BAPTISTCARE AND SYDNEY PROPERTY
DEVELOPMENT CONSULTANTS

SUPPLEMENTARY TRANSPORT
REPORT FOR BLOCK STUDY FOR
LAND BOUNDED BY PENNANT
HILLS ROAD, TINTERN AVENUE,
HOMELANDS AVENUE AND
MARTINS LANE, CARLINGFORD

APRIL 2017

REF: 10331/2

Existing weekday morning peak hour flows plus development traffic

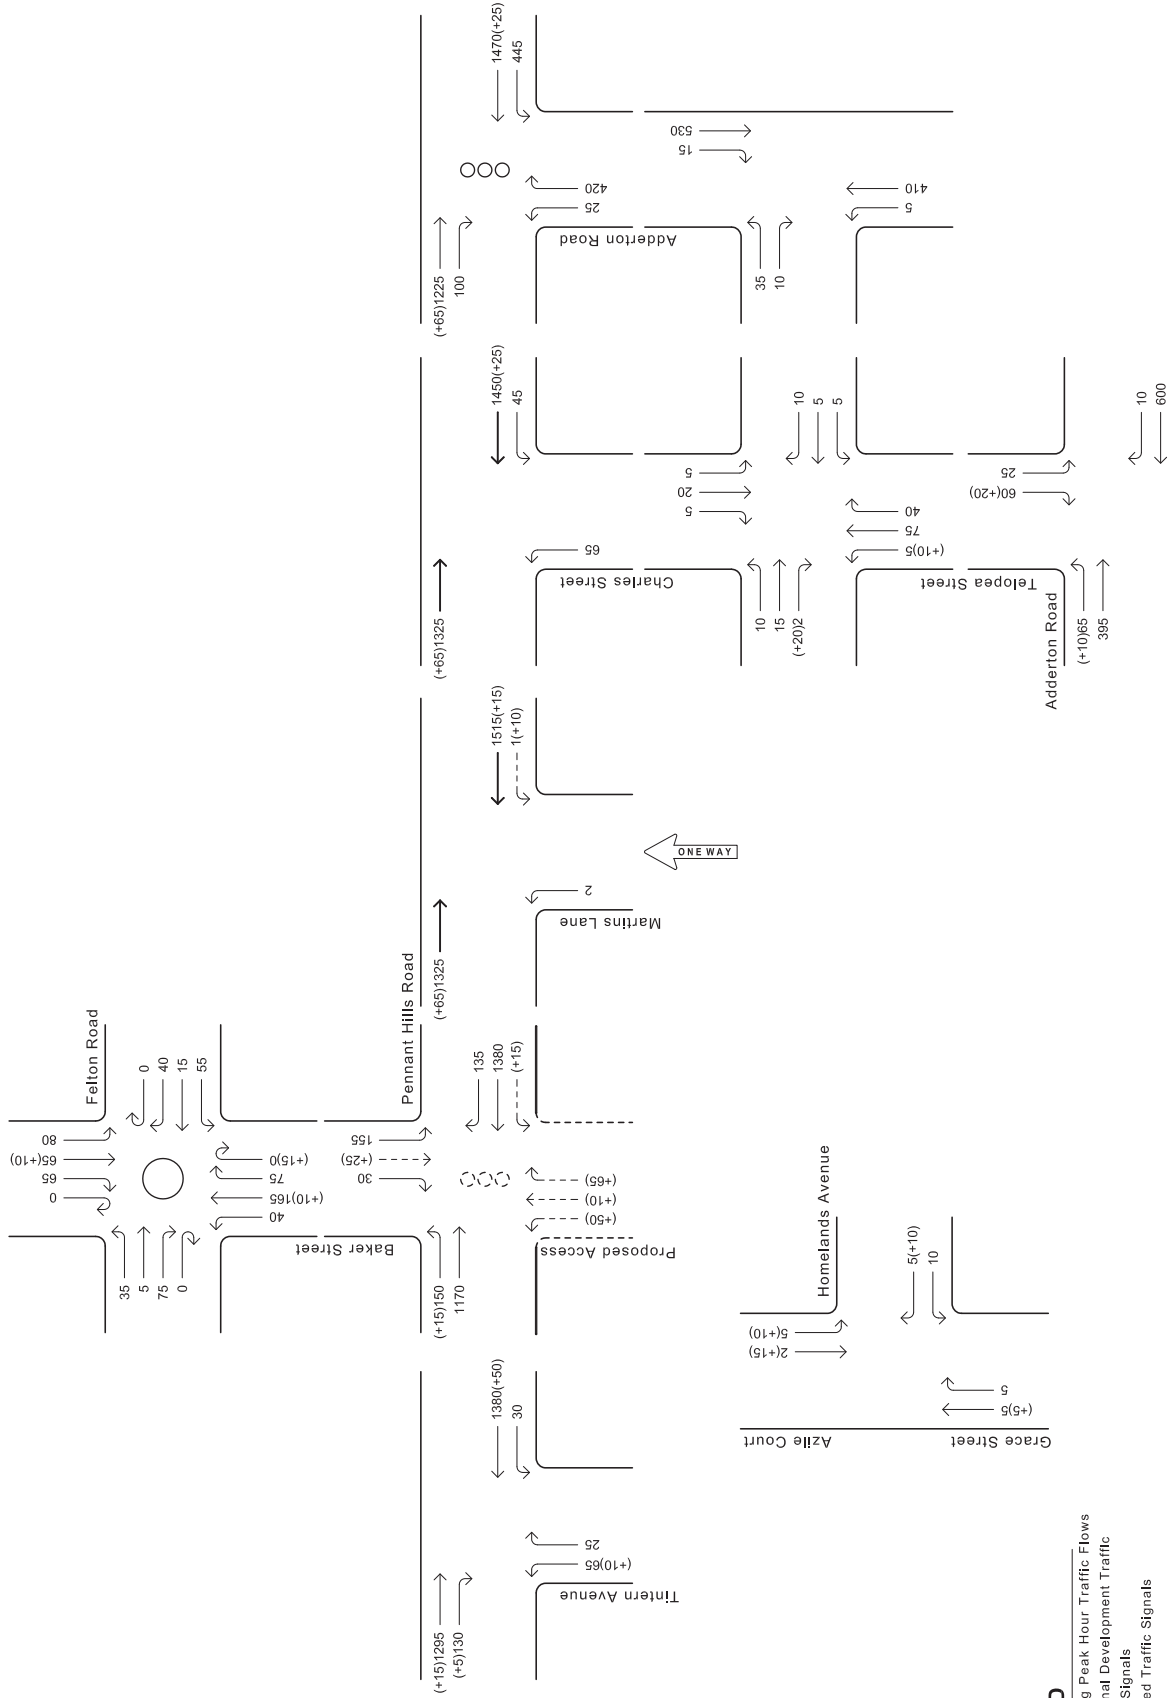
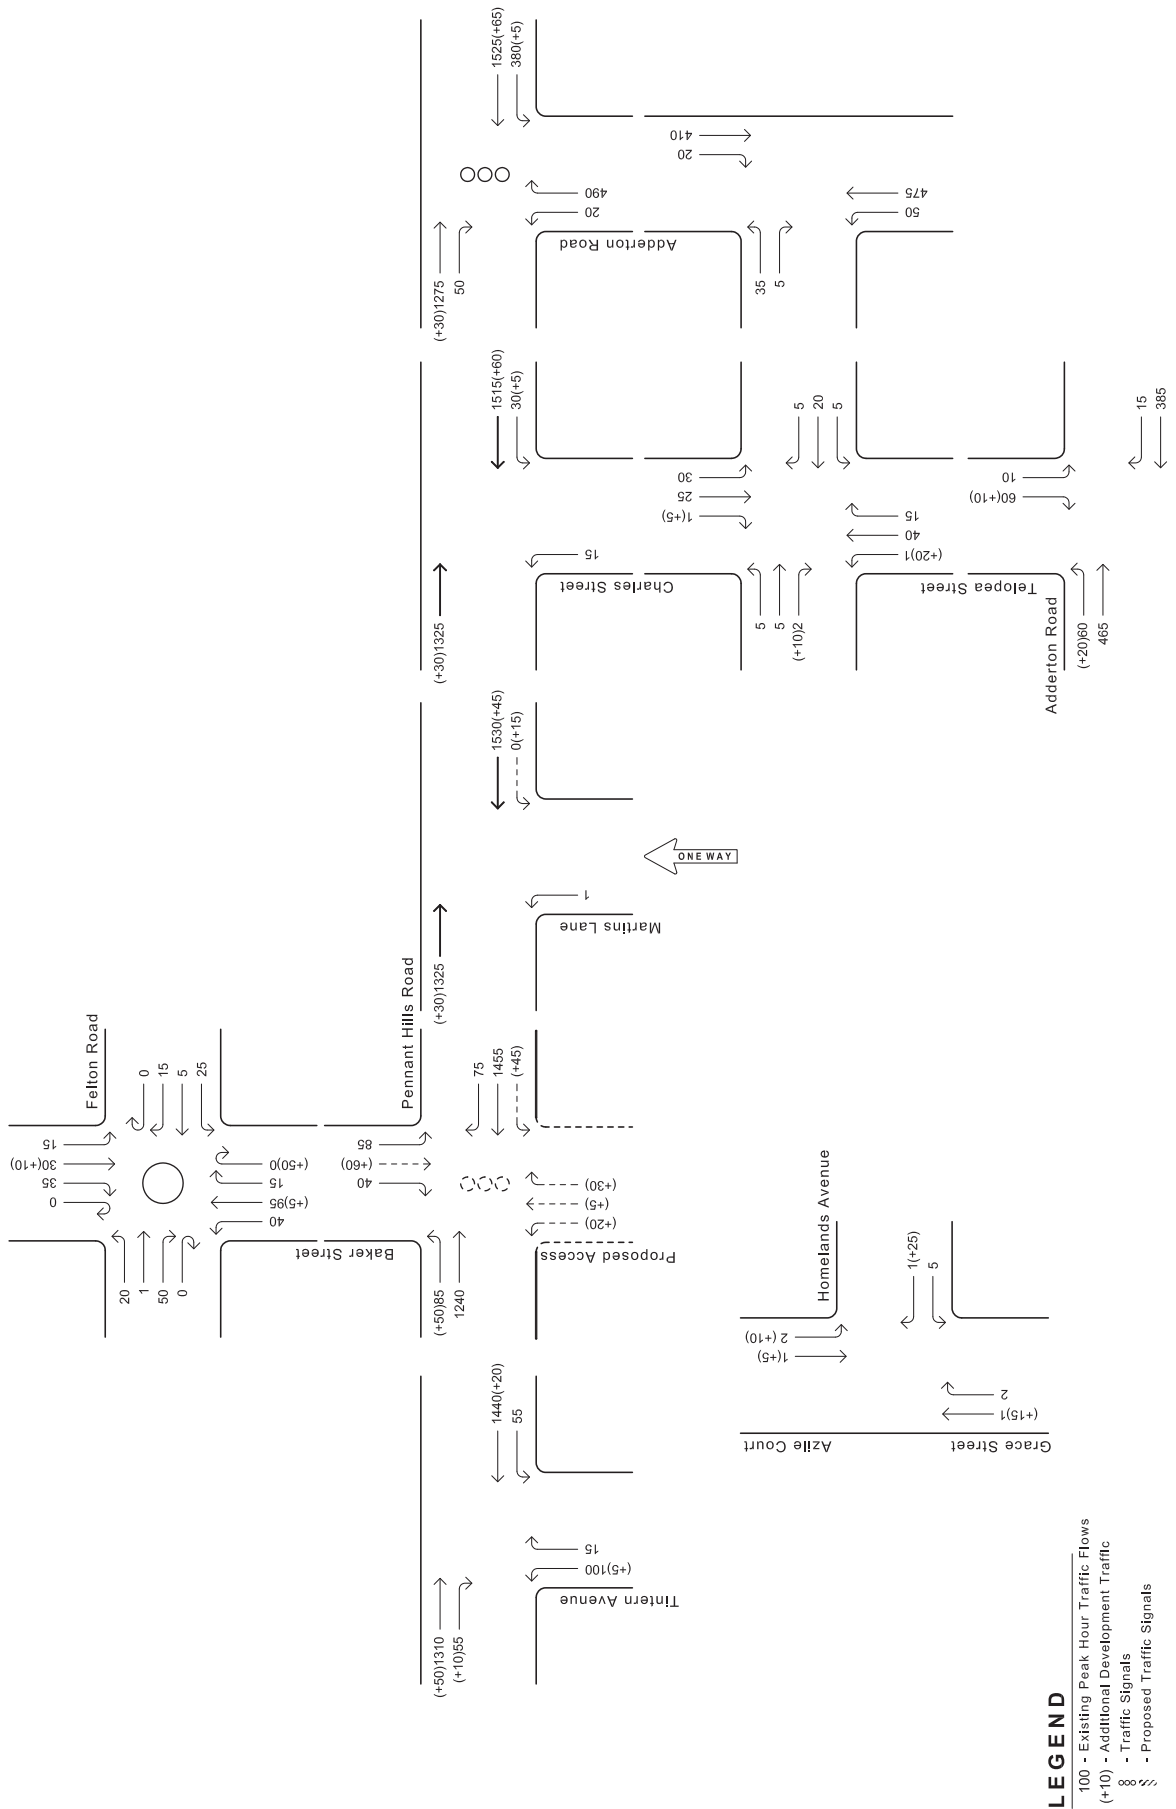
In addition, upon further review we've noted within Figure 2 and Figure 3 (see below) that there doesn't seem to be any additional traffic being generated into / out of Felton Road. However, I note that within the attached (Final Brief for Carlingford Block Study.pdf) that there would be a proposal at 241 Pennant Hills Road. As Felton Road is

a cul-de-sac at its eastern end and the fact that Roads and Maritime doesn't favour vehicular accesses to developments from Arterial roads where alternative access is available we're assuming that this proposal would be adding traffic into / out of Felton Road.

CBRK needs to clarify this matter.

2.30 Figures 2 and 3 show additional traffic from potential development in the block study precinct. They do not include traffic from potential development at 241 Pennant Hills Road. However, the SIDRA network analysis has included the additional Pennant Hills Road traffic from potential development at 241 Pennant Hills Road.
